RESPONSE TO NRC LTR DTD 03/30/78... FURNISHING ADDL INFO IN SUPPORT OF
APPLICANT'S REQUEST FOR A 50% WASTAGE STEAM GENERATOR TUBE PLUGGING
LIMIT... W/ATT.

June 9, 1978

H. B. ROBINSON STEAM ELECTRIC PLANT UNIT NO. 2
DOCKET NO. 50-261
LICENSE NO. DPR-23
STEAM GENERATOR TUBE PLUGGING LIMIT

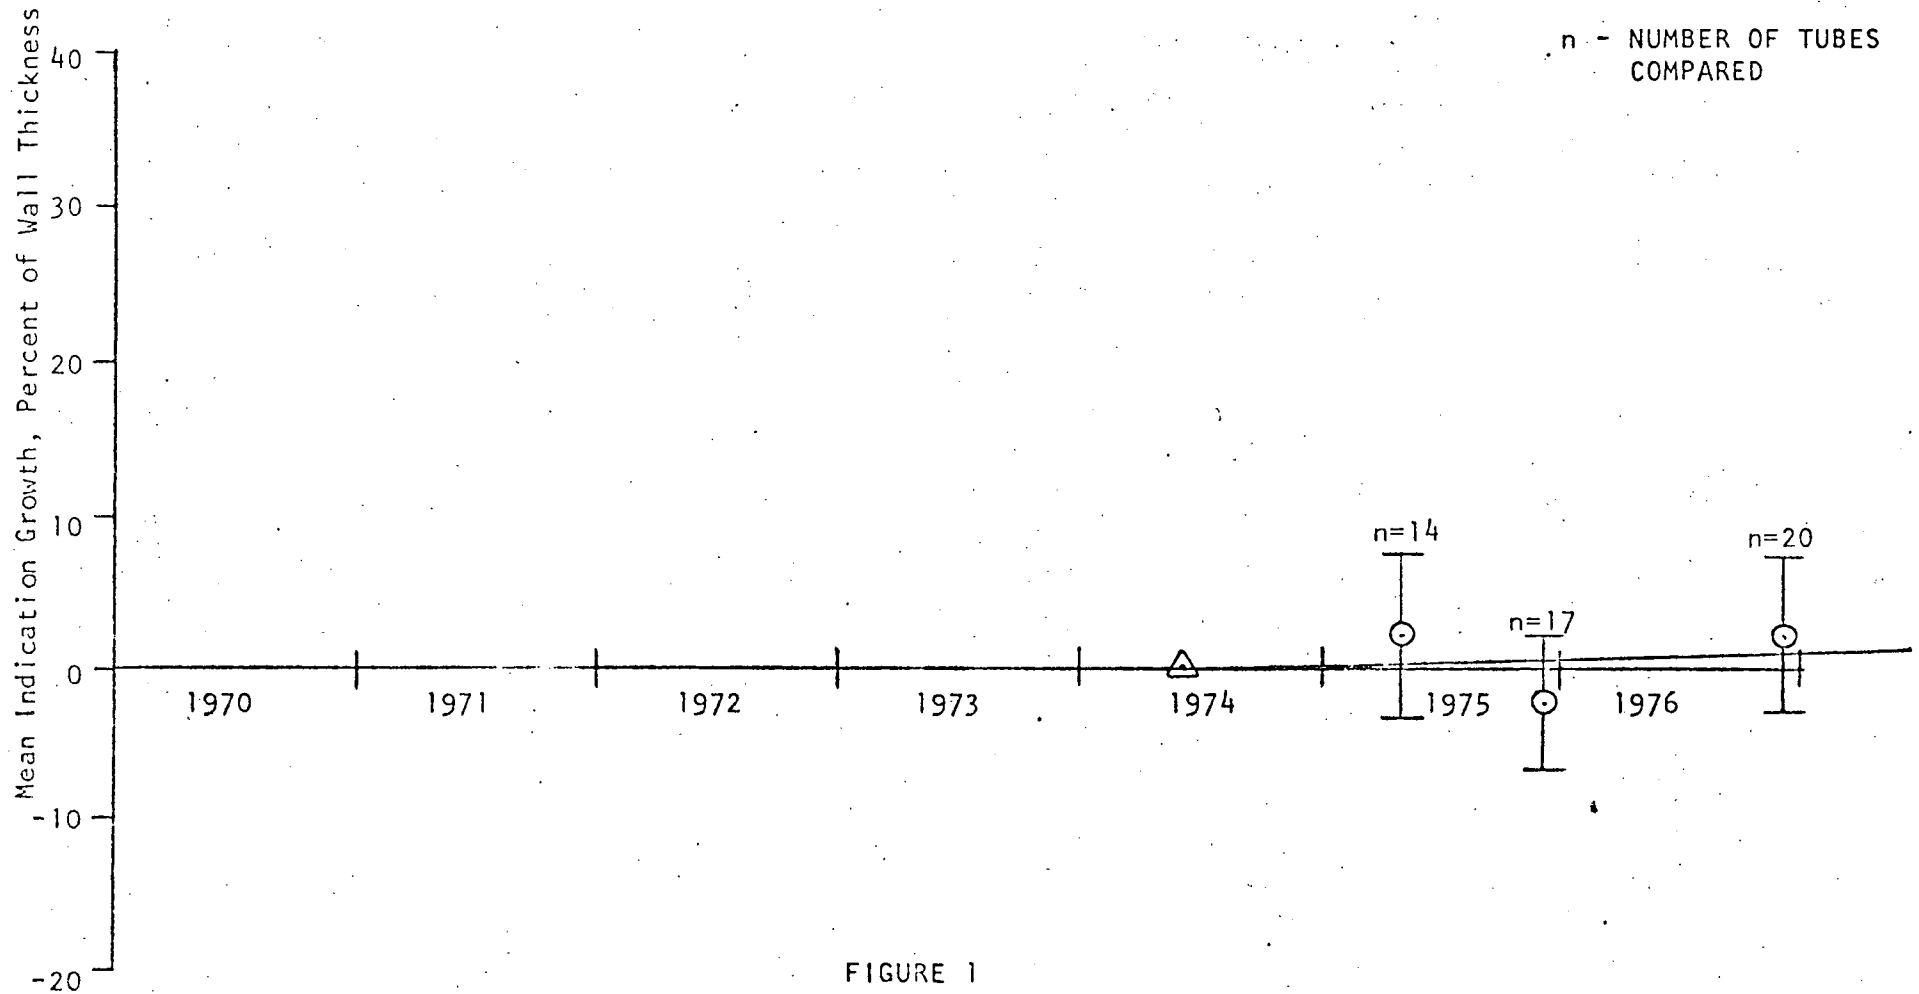
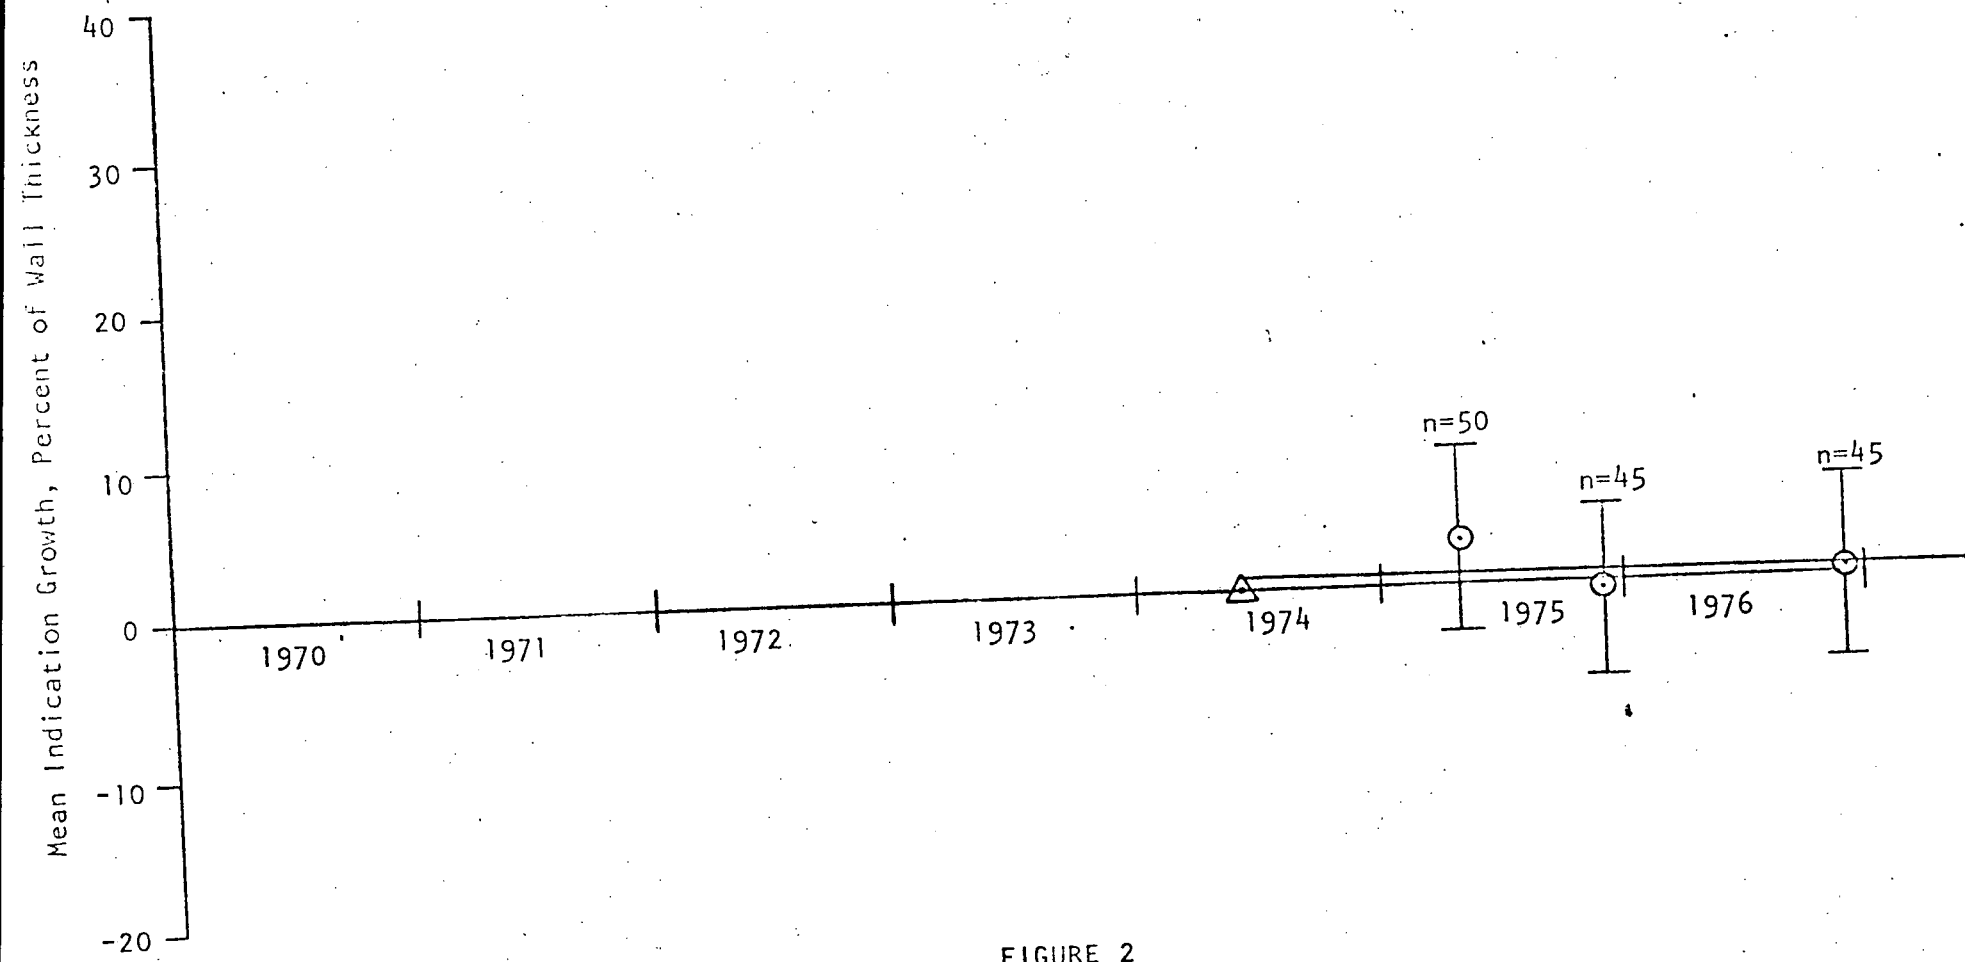
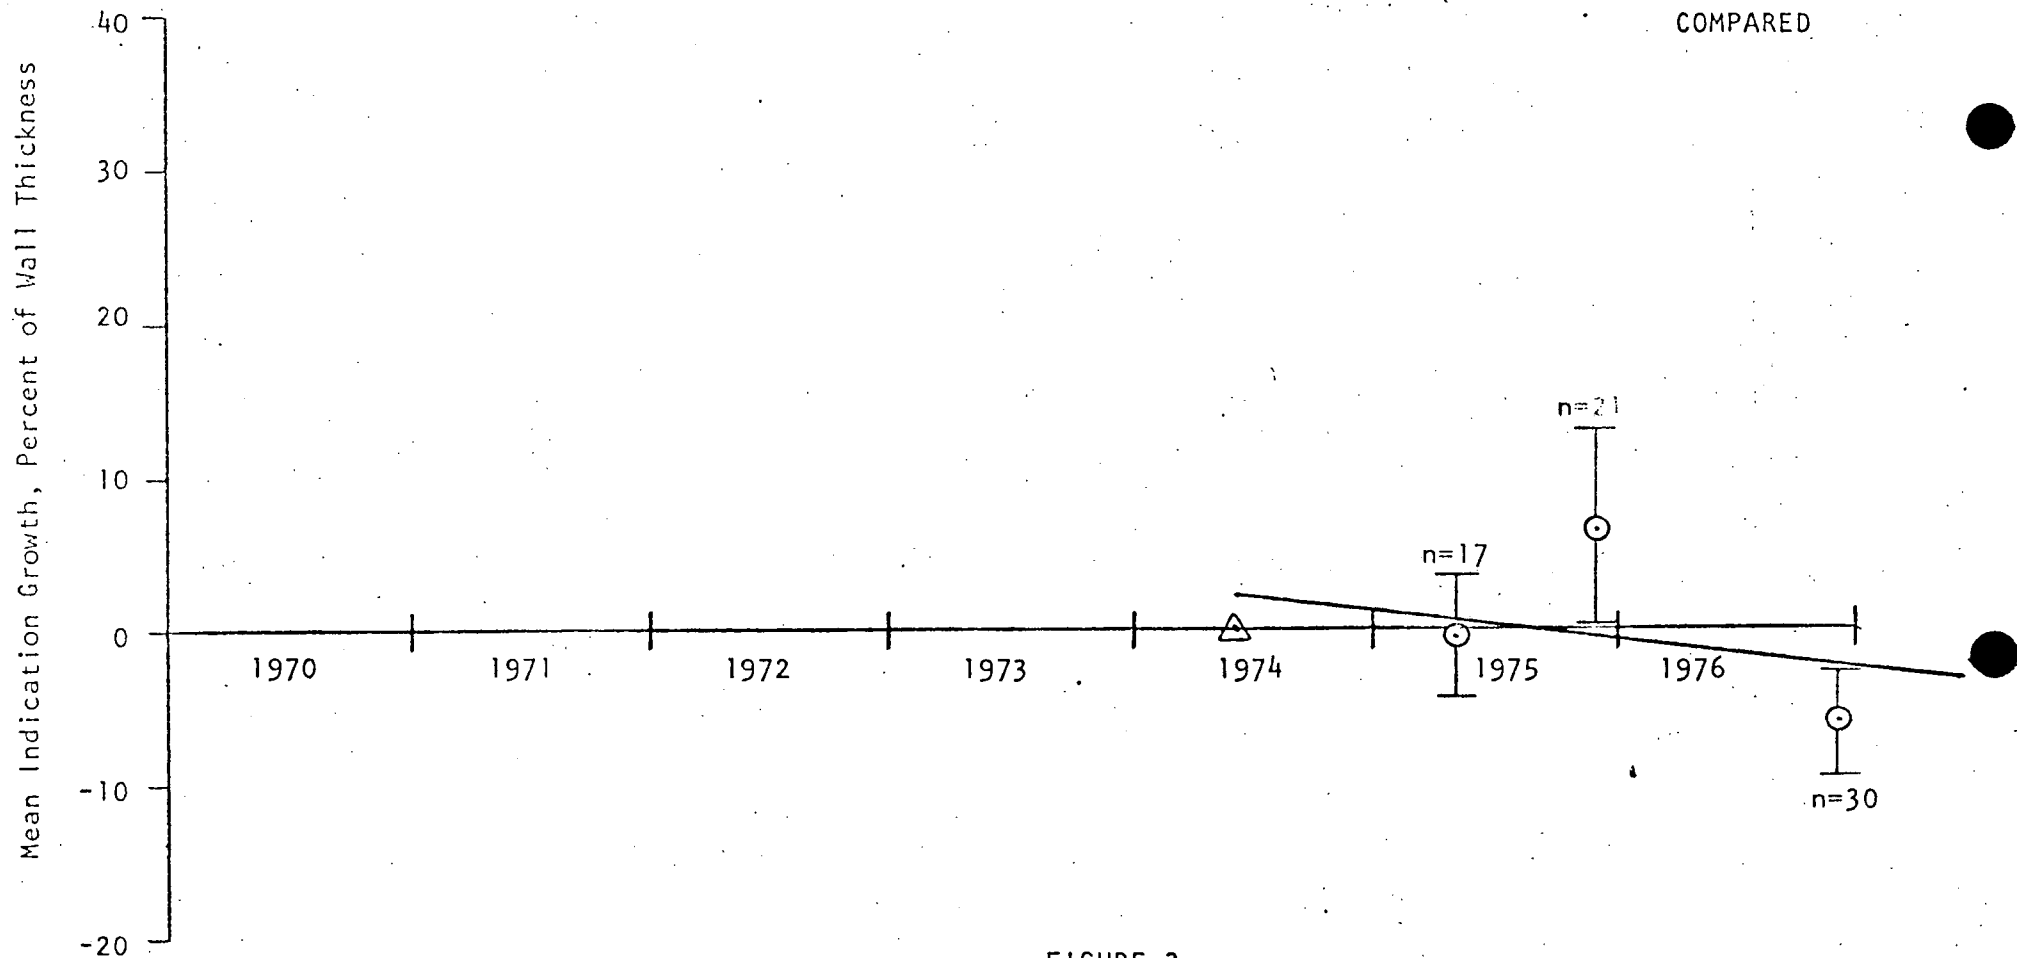
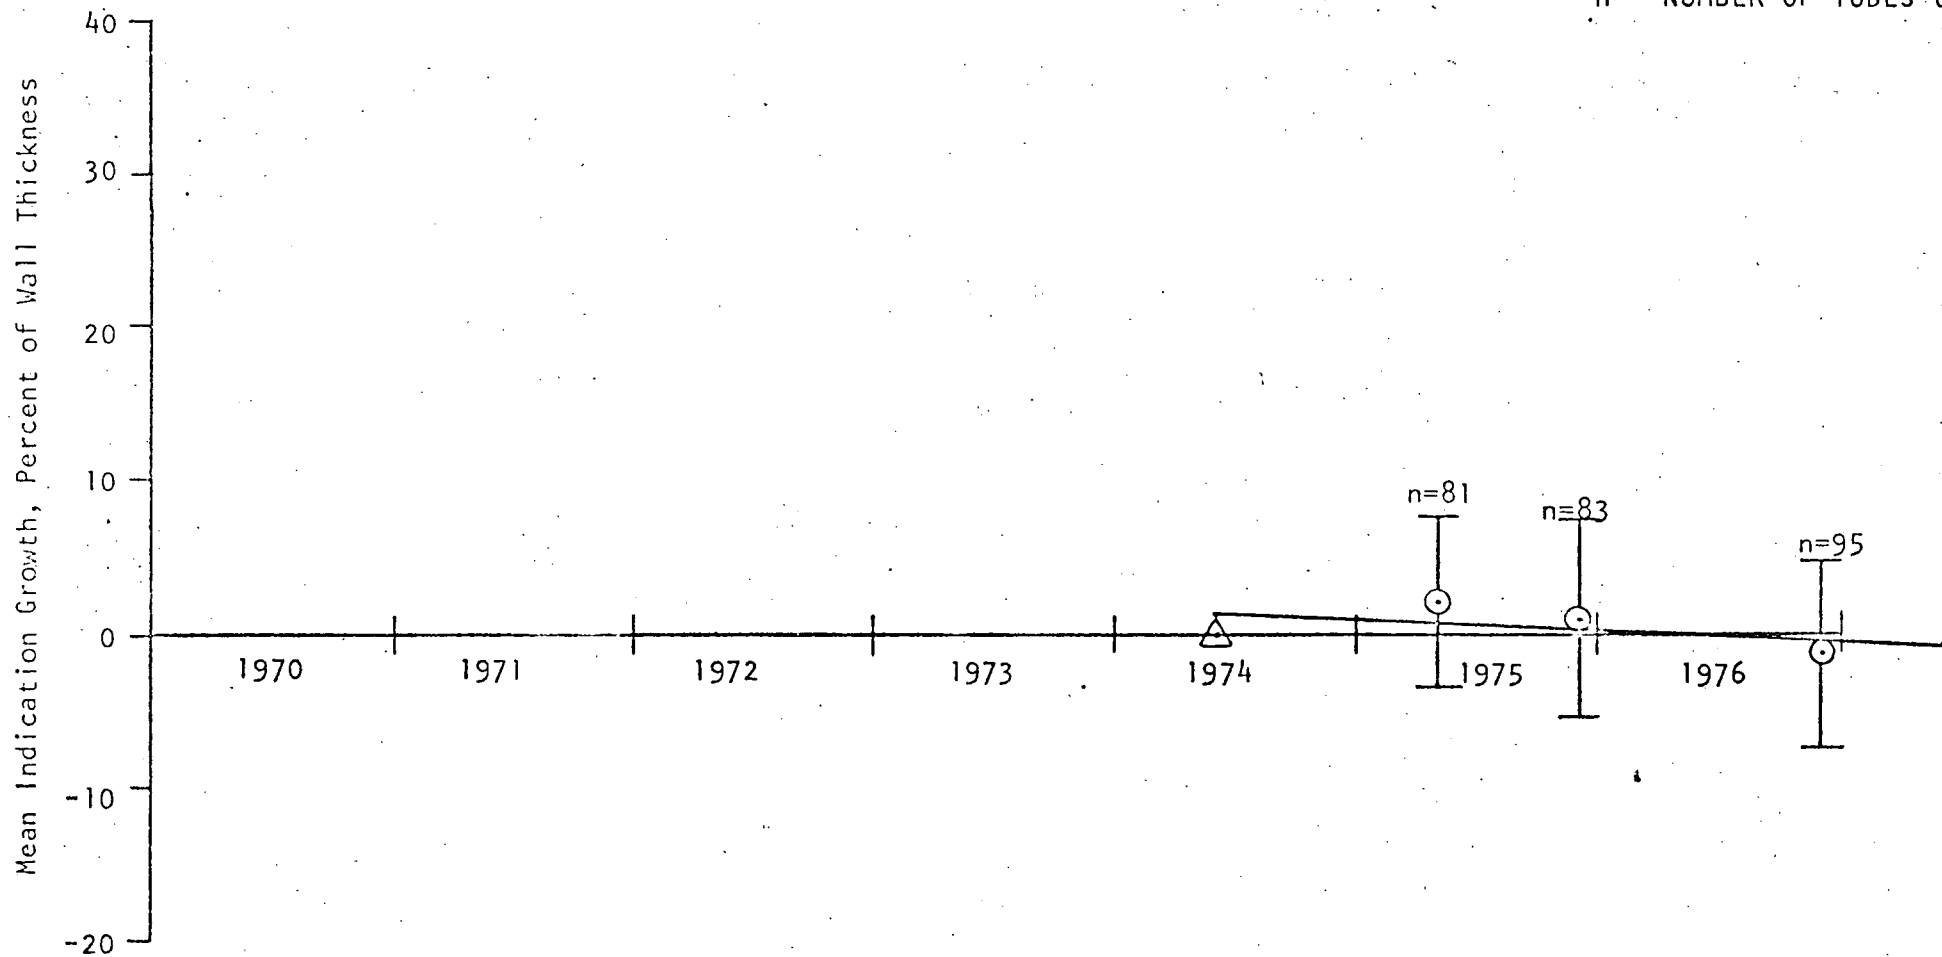
The data presented in Figures 36, 37 and 38 of Attachment I to the July 29, 1977 submittal, indicate relatively large standard deviations and instances of negative mean defect growth. Therefore, recalculate the mean defect growth between consecutive inspections using only those tubes with wastage of greater than 40% to the extent possible. This should minimize errors associated with the small eddy current indications. In addition to the three figures, provide a numerical tabulation of the mean and standard deviation for: 1) each of the three inspections of each generator; 2) each generator; and 3) the entire unit. Since a comparison of a significant sample of tubes must be made, it may be necessary to include tubes with defect indications of less than 40%.

Figures 1 through 4 plot the mean indication growth between consecutive inspections as a function of the later inspection, for each steam generator and for the entire unit. There were not enough comparisons to produce a meaningful sample if only those indications of $\geq 40\%$ were used. Therefore, in an attempt to reduce the errors associated with small indications, but still provide a meaningful sample size, indications $\geq 30\%$ were compared.

A linear regression analysis was performed on the four points plotted in each figure and the calculated lines were drawn. Note that these lines have negative slope in three of the four cases.
